Side Load Garage

Lot 125 - Duncan's Creek

245 Duncan Creek Road  
Lillington, NC 27546

# THE APEX - LH 'TRADITIONAL'

FIRST FLOOR PLAN 'TRADITIONAL'  
SCALE: 1/8"=1'-0" ON 11x17, 1/4"=1'-0" ON 22x34

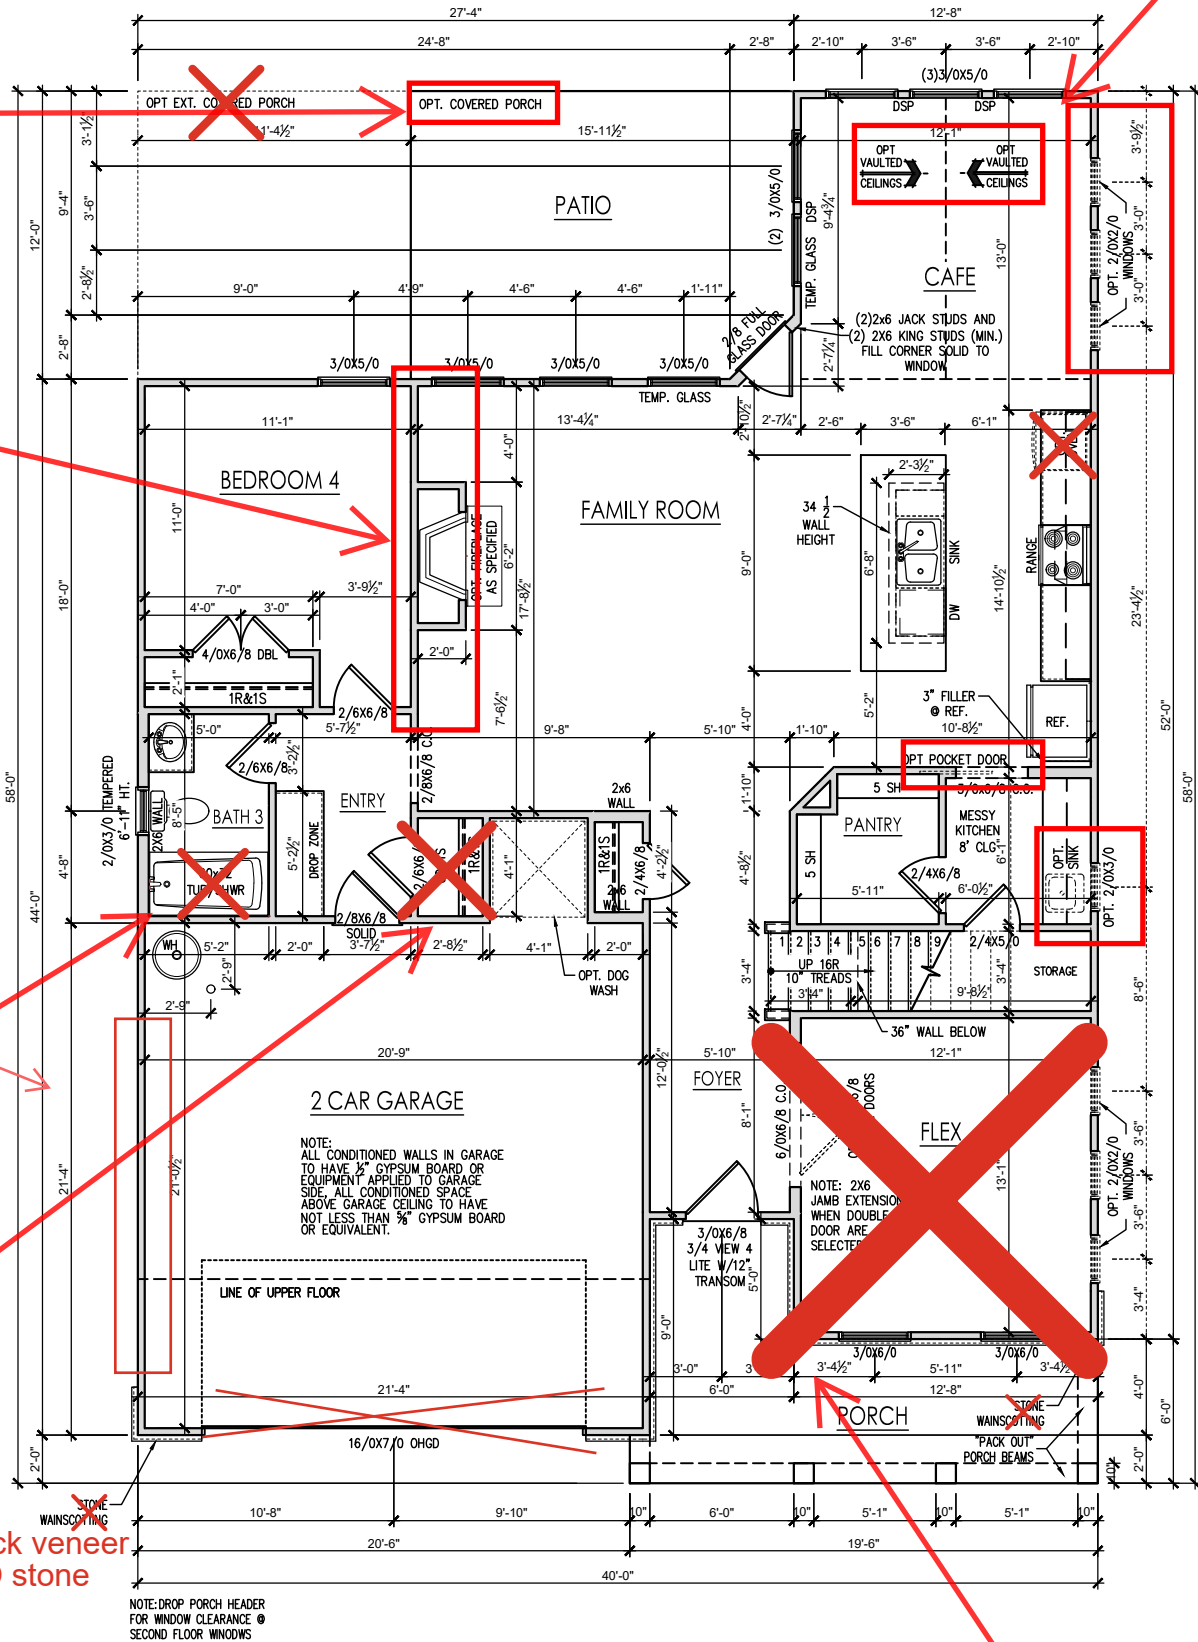
Covered Porch - 2.4.1a

Fireplace w/ Builtins - Removes left window in Family Room

Side Load Garage - 2.6c

Shower ILO Tub/ Shower Combo

Double Drop Zone - 2.1.1a

Brick veneer ILO stone

Double Pocket Office w/ Smart Door Delivery - 2.1.1a

SECOND FLOOR PLAN 'TRADITIONAL'  
SCALE: 1/8"=1'-0" ON 11x17, 1/4"=1'-0" ON 22x34

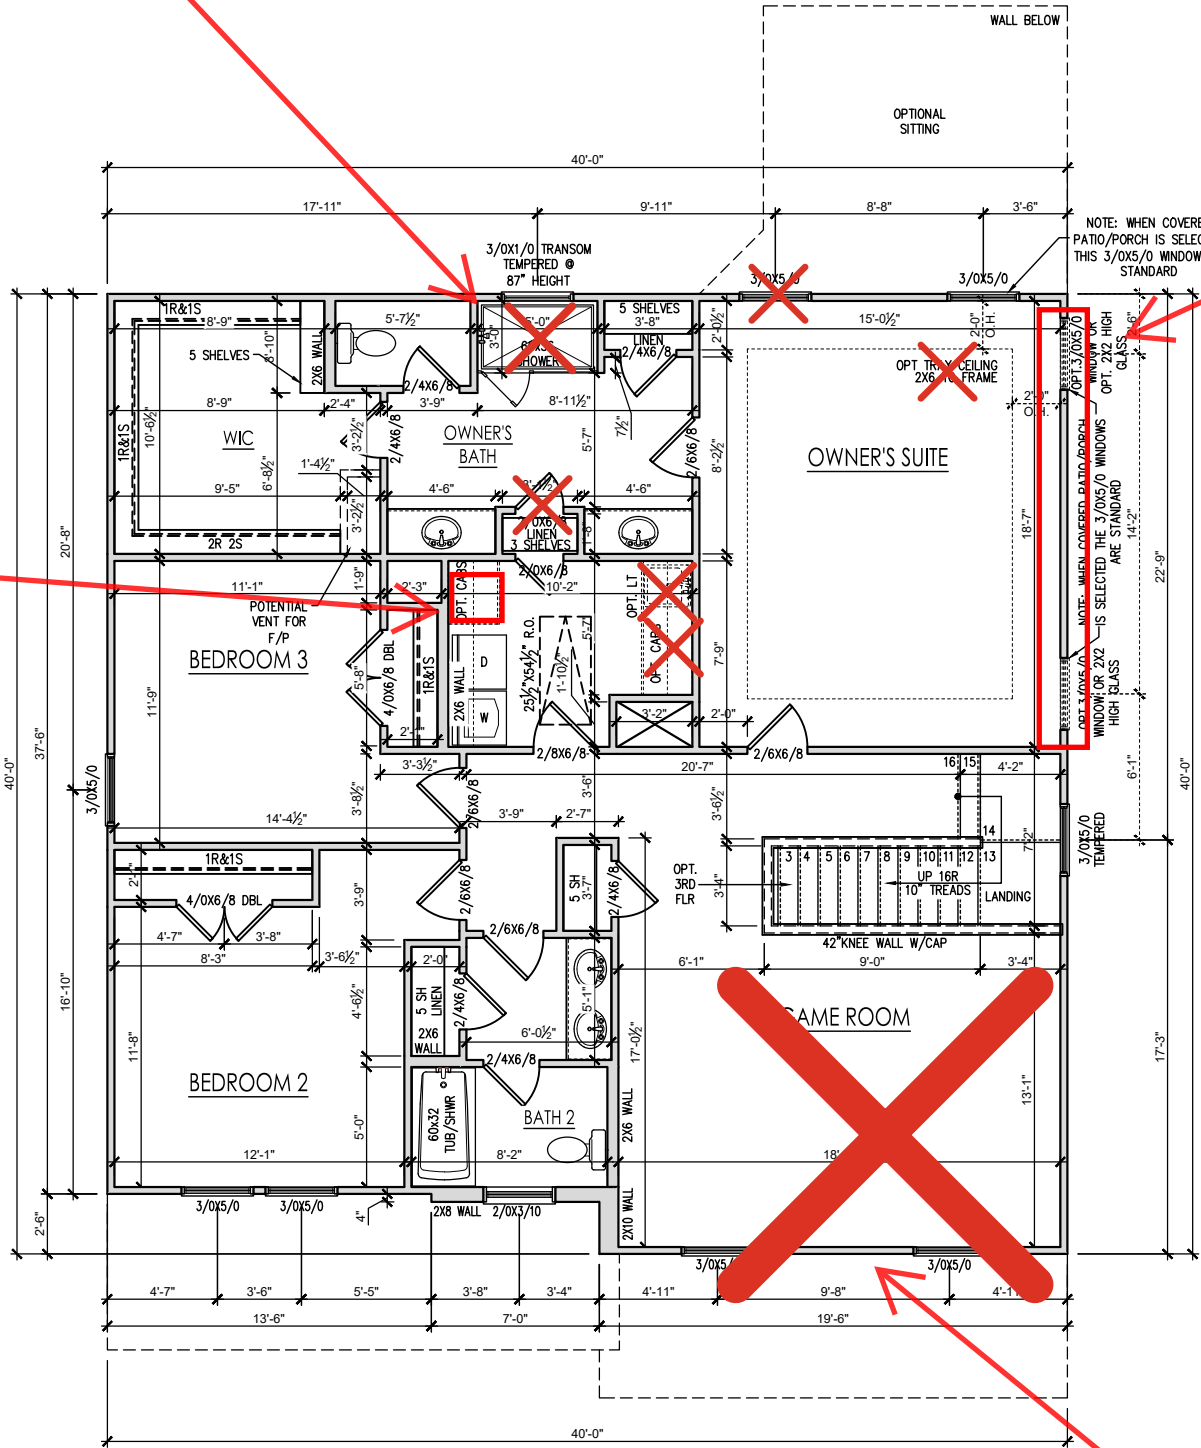
Shower w/ Bench - 2.2.1a

Free standing laundry tub beside Dryer.

Add Windows

Extended Game Room - 2.2.1a. Overall dimension changes with option.

FRONT ELEVATION 'TRADITIONAL' (CRAWL/STEM WALL)  
SCALE: 1/4" = 1'-0" ON 22x34, 1/8" = 1'-0" ON 11x17  
SEE FOUNDATION PAGES FOR FOUNDATION TYPE

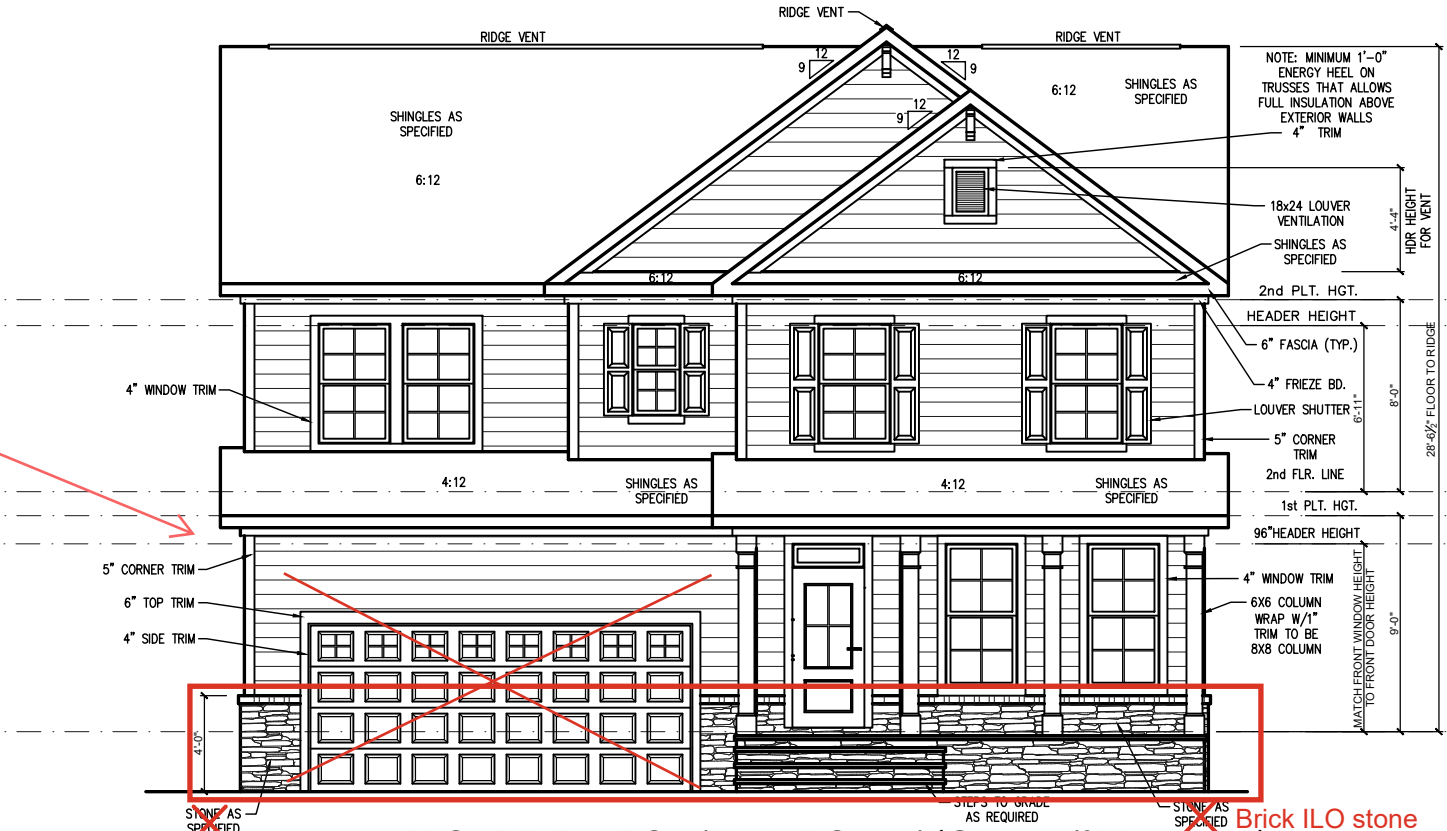
Side Load Garage  
Front Elevation -  
2.6.1a

Brick ILO  
stone

REAR ELEVATION 'TRADITIONAL' (CRAWL/STEM WALL)  
SCALE: 1/4" = 1'-0" ON 22x34, 1/8" = 1'-0" ON 11x17  
SEE FOUNDATION PAGES FOR FOUNDATION TYPE

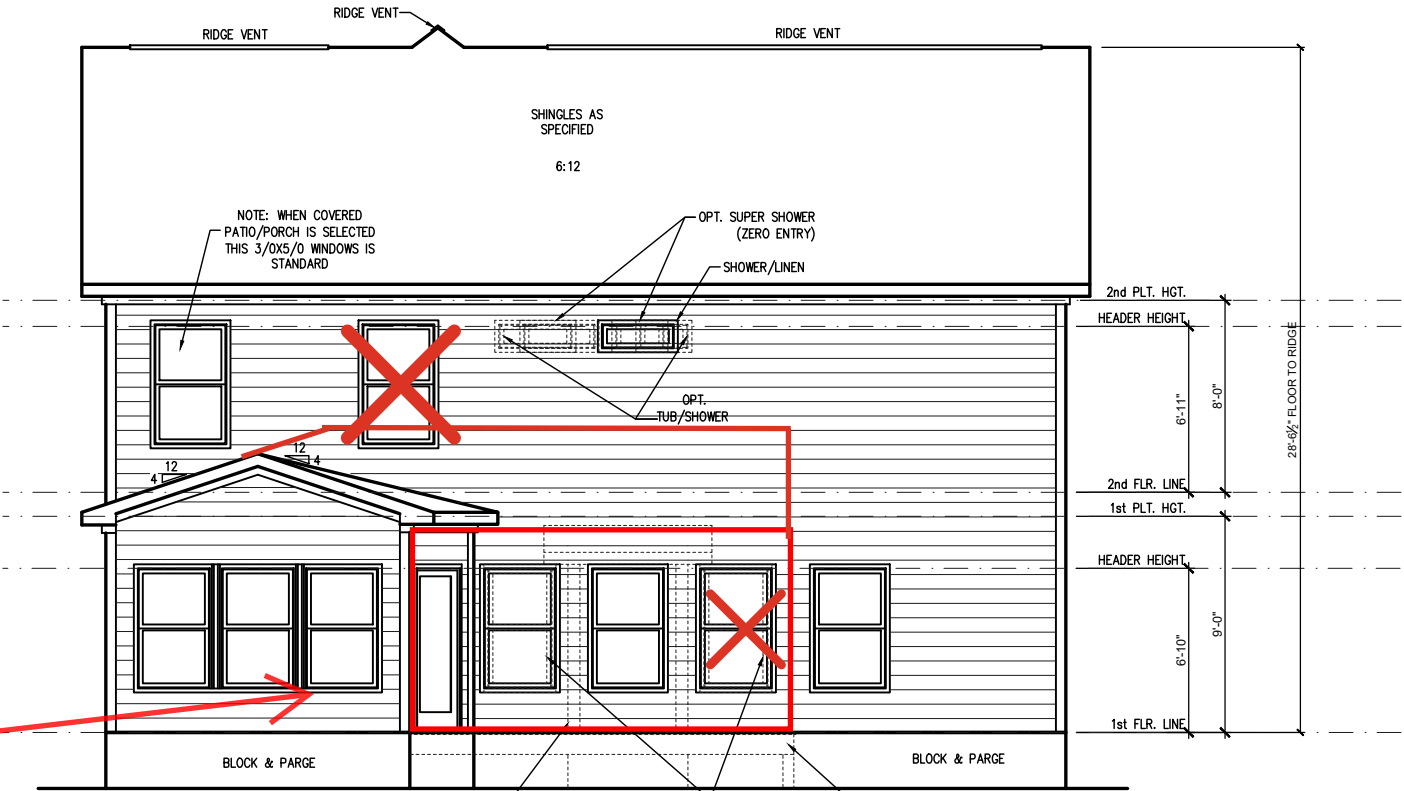
Covered Porch -  
2.4.1a

LEFT SIDE ELEVATION 'TRADITIONAL' (CRAWL/STEM WALL)  
SCALE: 1/4" = 1'-0" ON 22x34, 1/8" = 1'-0" ON 11x17  
SEE FOUNDATION PAGES FOR FOUNDATION TYPE

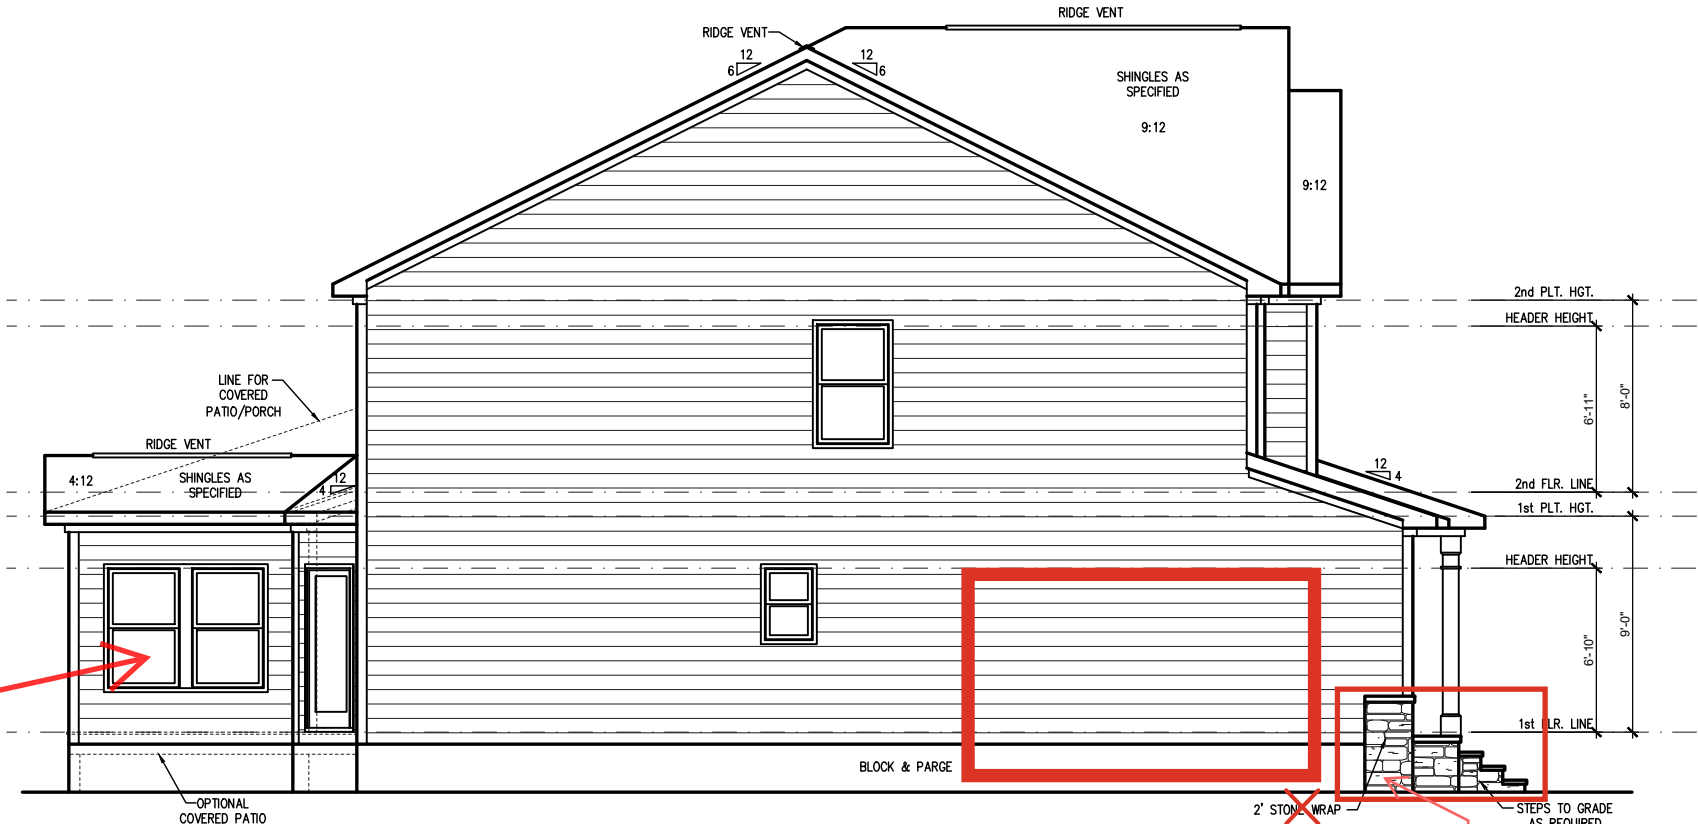
Covered Porch

Brick ILO stone

Side Load Garage  
Left Elevation -  
2.6.1a

RIGHT SIDE ELEVATION 'TRADITIONAL' (CRAWL/STEM WALL)  
SCALE: 1/4" = 1'-0" ON 22x34, 1/8" = 1'-0" ON 11x17  
SEE FOUNDATION PAGES FOR FOUNDATION TYPE

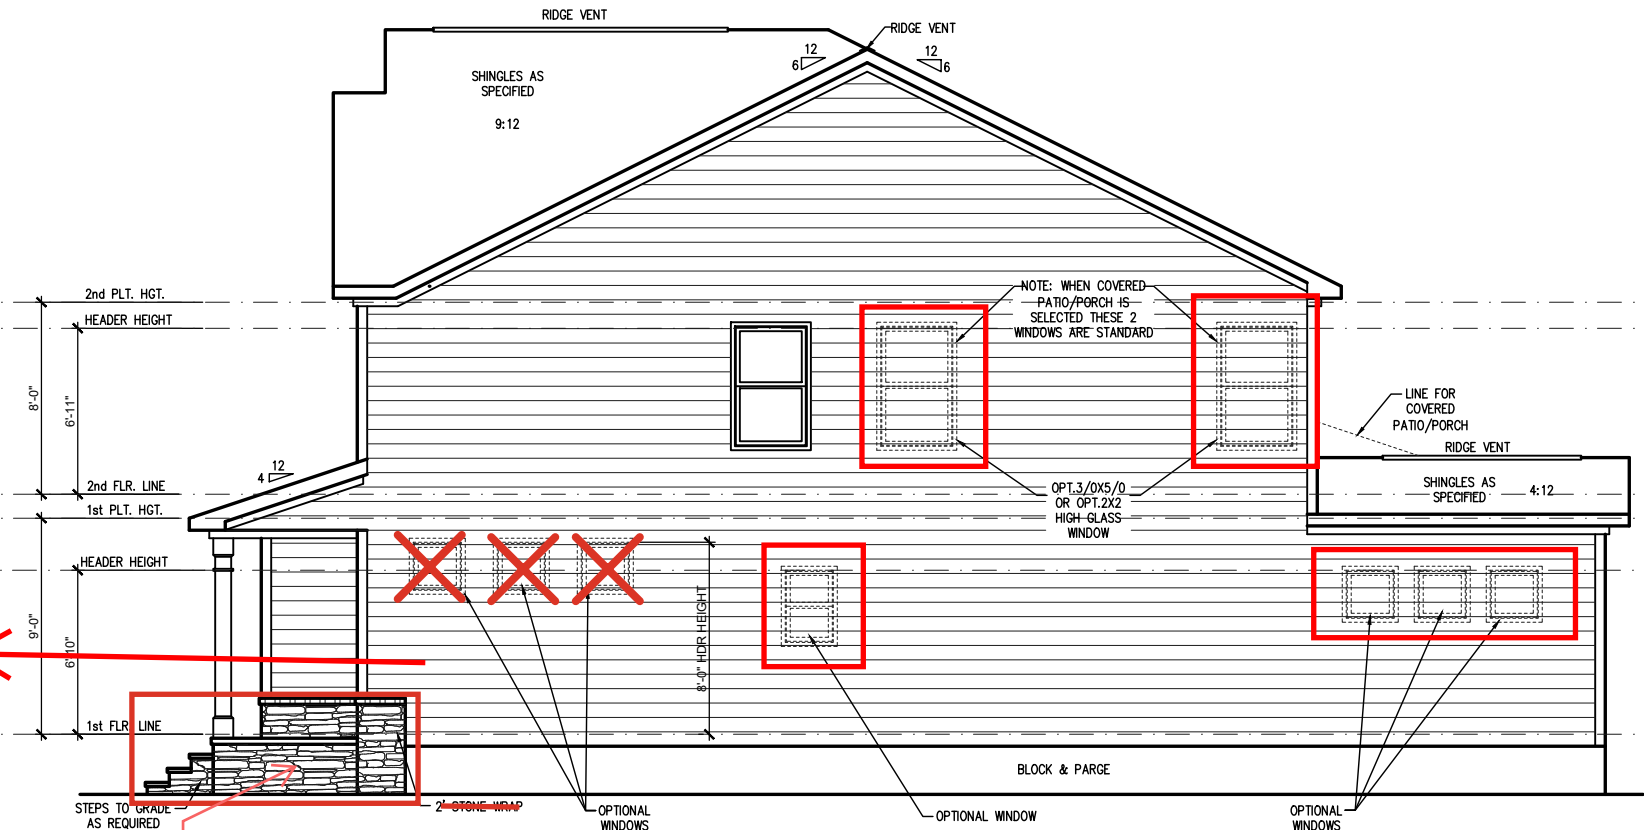
OPT. PKT. OFFICE

brick ILO stone

CRAWL FND. W/ SMART DELIVERY DR. W/ DBL POCK. OFFICE  
SCALE: 1/8"=1'-0" ON 11x17, 1/4"=1'-0" ON 22x34

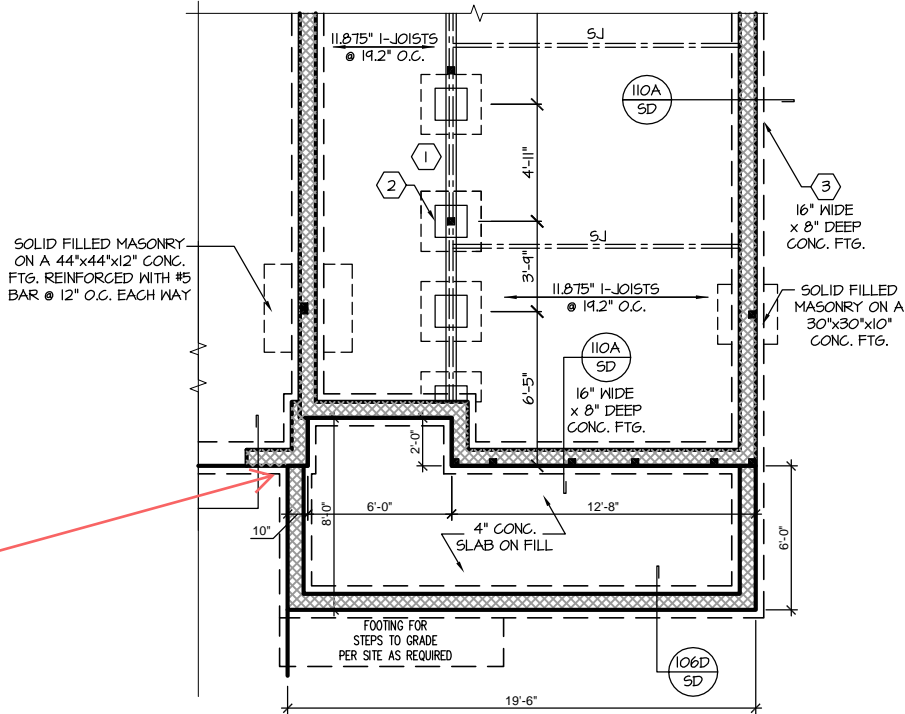
Double Pocket Office  
w/ Smart Door Delivery  
- Extends home and  
porch out - S-1.2.1

DIMENSIONS ARE TO  
FRAMING, ADD 5" FOR  
BRICK VENEER.

#### FIRST FLOOR PLAN 'TRADITIONAL'

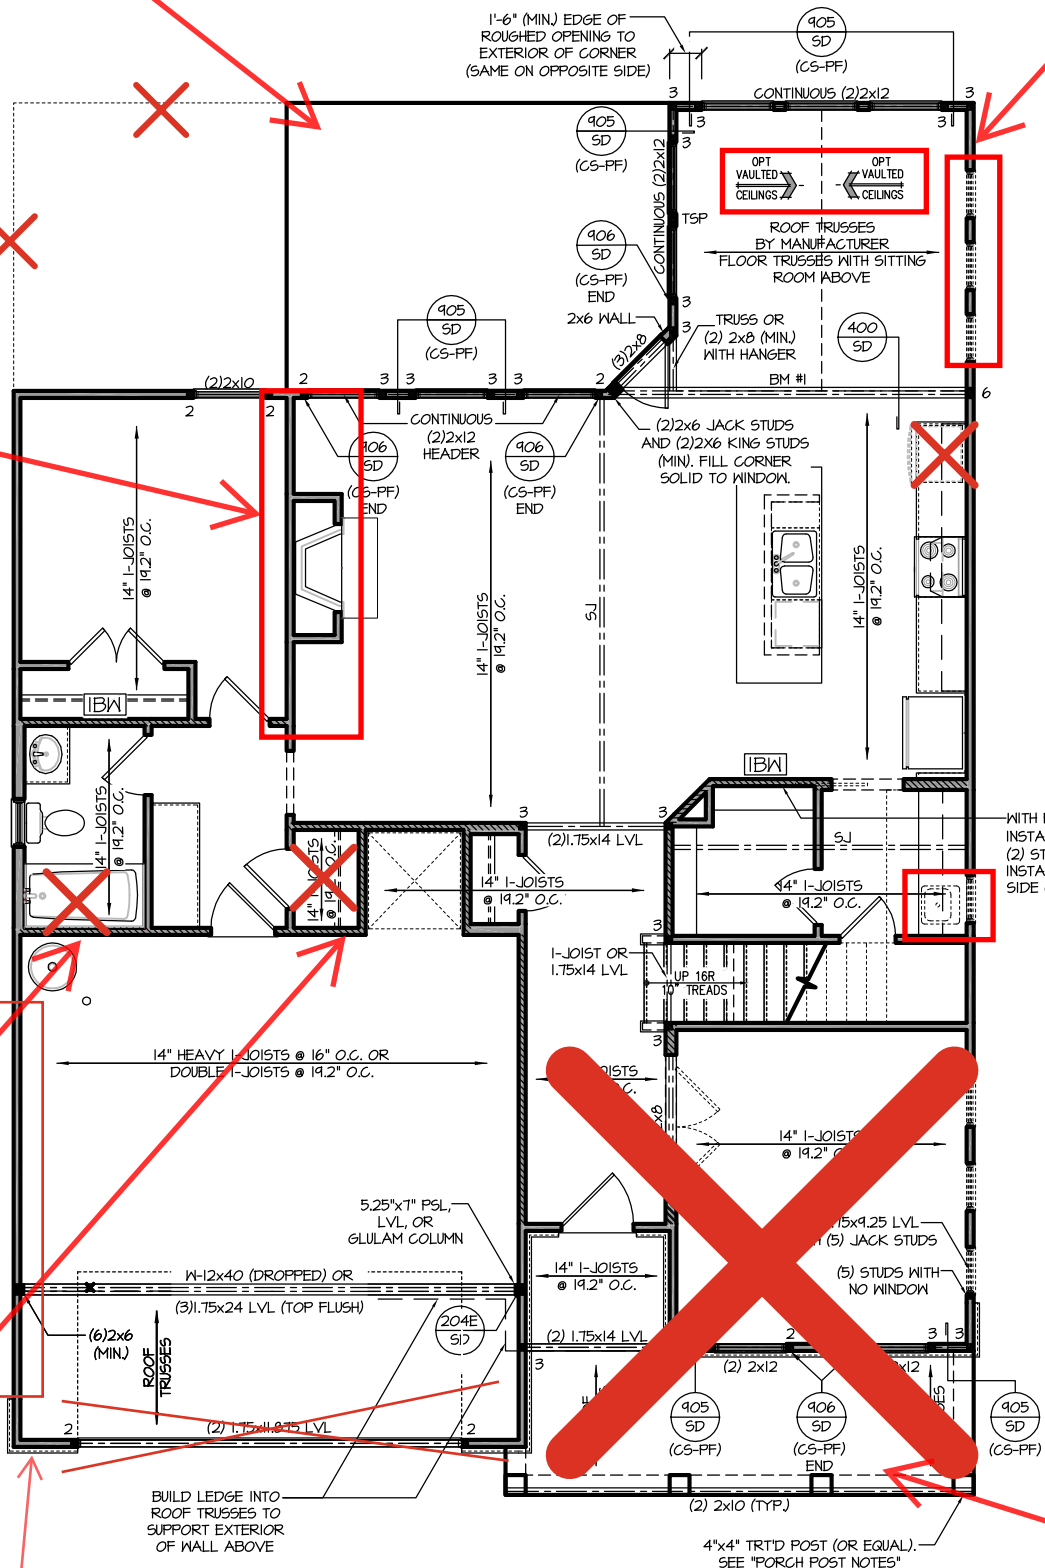
BM #1: - (3)1.75x16 LVL (BOTTOM FLUSH)  
(NO SITTING ROOM ABOVE)  
- W-10x26 WITH SITTING ROOM ABOVE

Fireplace w/ Builtins -  
Removes Left Window  
in Family - S-2.1.1

Side Load Garage  
- S-2.1.2

Double Pocket Office w/ Smart  
Door Delivery - Front porch  
and front of home extend out -  
S-2.1.1
